20 August 2019

RE: CANYON MINE CLOSURE AND AQUIFER PROTECTION PERMIT

Sierra Club's Grand Canyon Chapter, Center for Biological Diversity, Grand Canyon Trust, and Wild Arizona (the "Conservation Groups") provide the following comments in response to ADEQ's proposed renewal of the Aquifer Protection Permit for the Non-Stormwater Impoundment for Canyon Mine under a general permit (Currently a Type 3.04 General Aquifer Protection Permit with Inventory No. 100333, LTF No. 60849, USAS No. 030032-02; expiration date August 31, 2019). These comments supplement our August 2nd letter requesting public hearings and a comment period in advance of the permit approval.

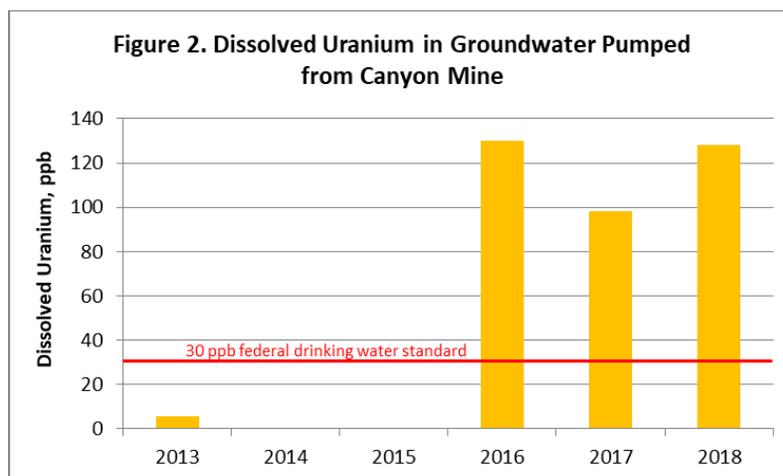
Just as regulators had been warned, construction of the mine shaft at Canyon Mine in 2016 and 2017 pierced perched aquifers associated with the Coconino Formation, causing ongoing severe flooding of the mine with groundwater. According to reports submitted to ADEQ by Energy Fuels, groundwater flooding increased from more than 900,000 gallons in 2016 to more than 8 million gallons in 2017¹² and nearly 10 million gallons in 2018 (Figure 1).

Groundwater flooding now occurring at the Canyon Mine undermines key assumptions upon which the Canyon Mine was designed, per the Plan of Operations, and it undermines key assumptions on which the Canyon Mine Final Environmental Impact Statement (FEIS) and Record of Decision rely. The FEIS, which approves the mining according to the Plan of Operations, concludes that the “low potential for encountering groundwater” “effectively eliminates the possibility of contaminating the Redwall-Muav aquifer.” FEIS at 26. It states:
